# NFLA New Nuclear Monitor Policy Briefing

Edition Number 55, 21<sup>st</sup> December 2018

## NFLA All Ireland Forum model submission to Irish Councils to respond to a transboundary environmental consultation of the potential impacts of the proposed Wylfa B development

Graph 1. Noble gas concentrations from Gundremmingen C. 1/2 hourly values. Sept 19 to 25

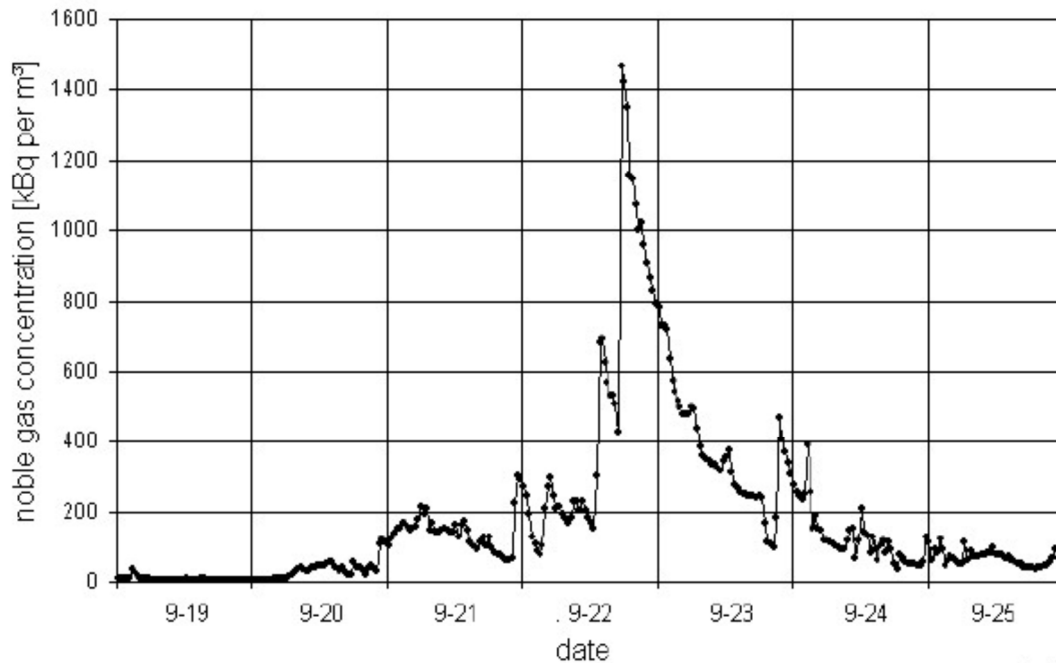
The evidence for radionuclide spikes during refuelling was revealed for the first time in November 2011. Published data from the Gundremmingen NPP in Southern Germany showed that very large spikes of radioactive noble gases were released during refuelling than were emitted during normal power operation throughout the rest of the year. (See graph below). According to the International Physicians for the Prevention of Nuclear War (IPPNW) in Germany, the normal emission concentration during the rest of the year is about 3kBq/m<sup>3</sup> but during inspection/refuelling episodes this concentration increased to ~700kBq/m<sup>3</sup> with a peak of 1,470kBq/m<sup>3</sup>. Nuclide emissions during the period of refuelling were about 65% of total annual releases. Noble gas concentrations can be used as a proxy for other gaseous emissions, including tritium, C-14 and iodine releases. (11)

In order to refuel, the pressure vessels of all nuclear reactors are opened up about once a year. This releases large volumes of radioactive gases and vapours, including noble gases, tritium, carbon-14 and iodine-131, to the environment. Until now, these nuclide releases had been published only as annual data throughout the world. After repeated requests by the SPD-Green Party Government in Bavaria, half-hourly data were made available for scientific evaluation for the first time. Brief exposures to high concentrations are more hazardous to residents near NPPs than chronic exposures to low concentrations. Exposures to high concentrations result in higher internal doses, so these nuclide spikes during re-fuelling could go a long way to explaining the increased incidences of child leukaemias near NPPs shown by the KiKK findings.
